July 12, 2018

Subject: Addendum # 1 – Sow Farm Design
              Groundwater Discharge Permit Application and Report
              Dated January 4, 2018 - GEM Report# RE0617
              For Smithfield Hog Production
              Christensen Finisher Farm Site
              Millard County, Utah

ENC: Sow Farm Design and Lagoon Sizing
Sections Changed Below:

Figure 4- 1 Sow Farm Waste Diagram

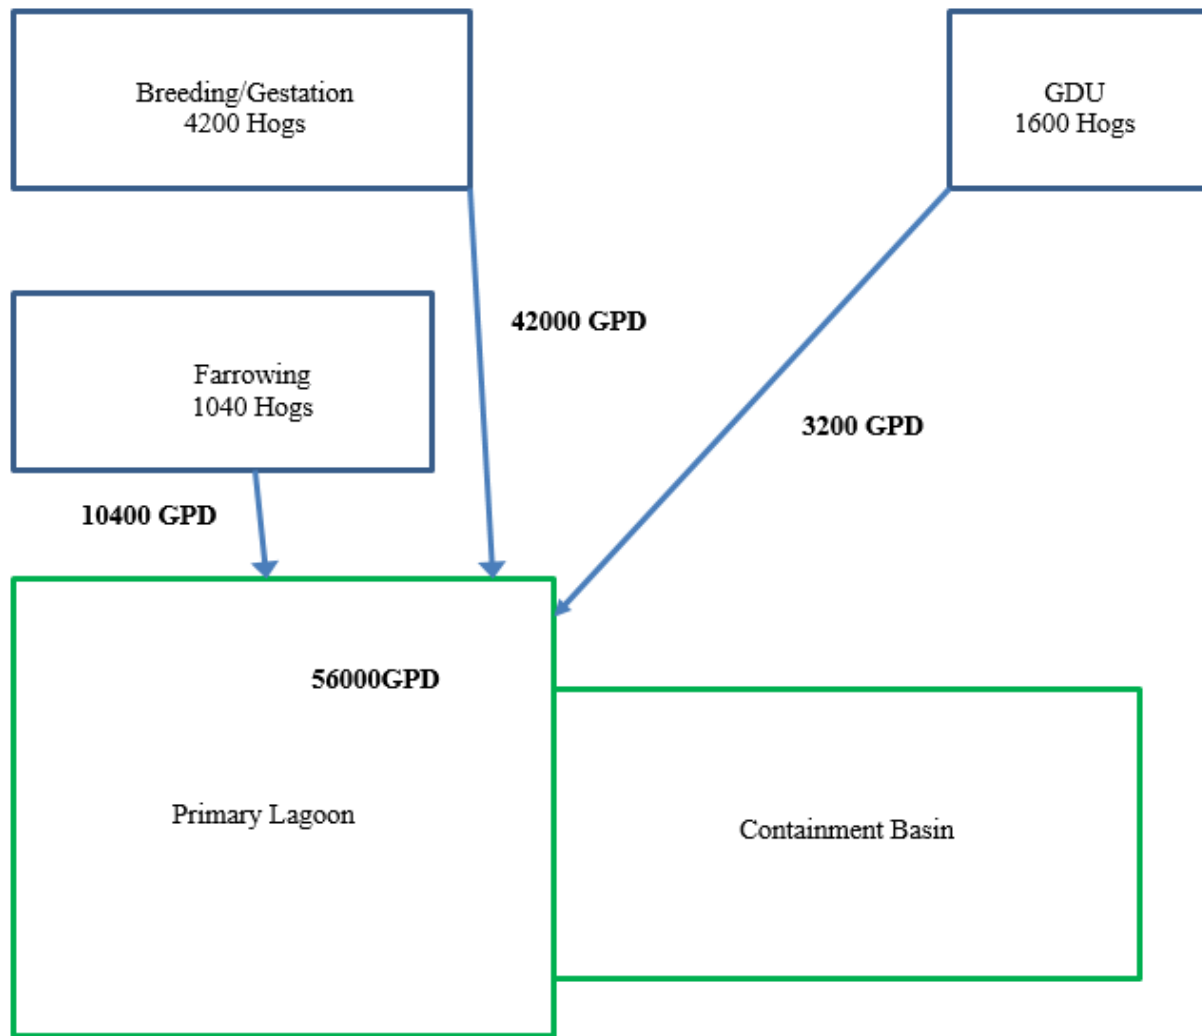
A diagram of the overall operation of the sow farm facility is found in Figure 4-1.

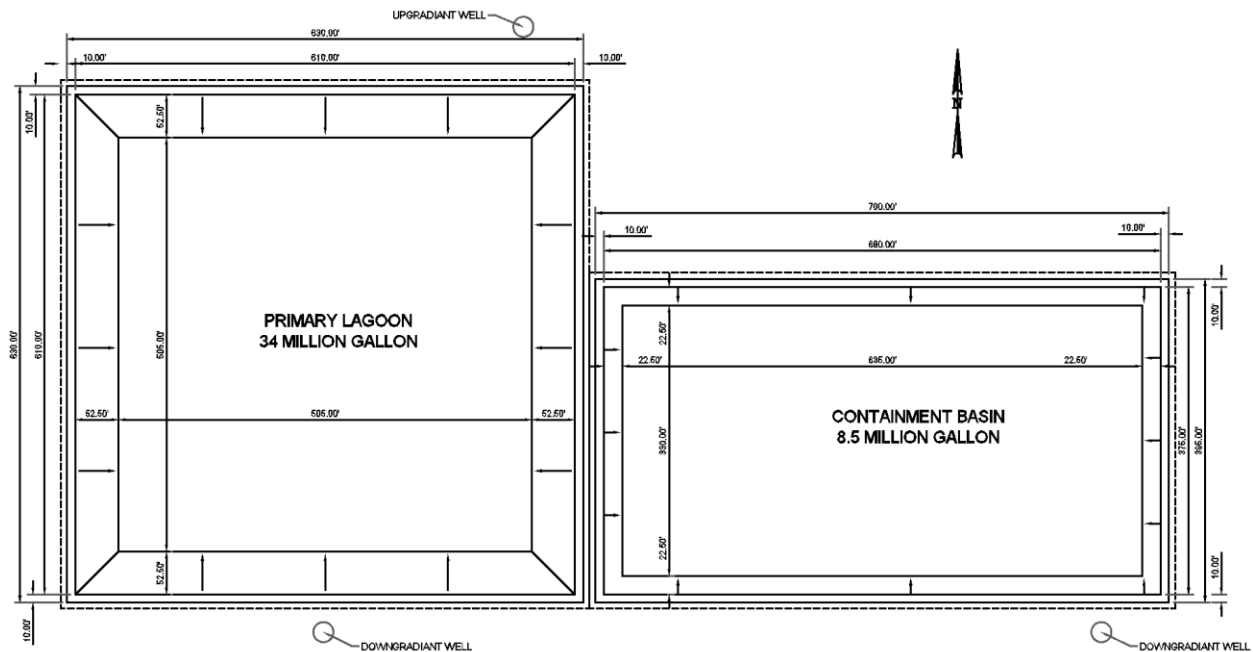
A plan view of the containment basin is shown in **Figure 4-3**
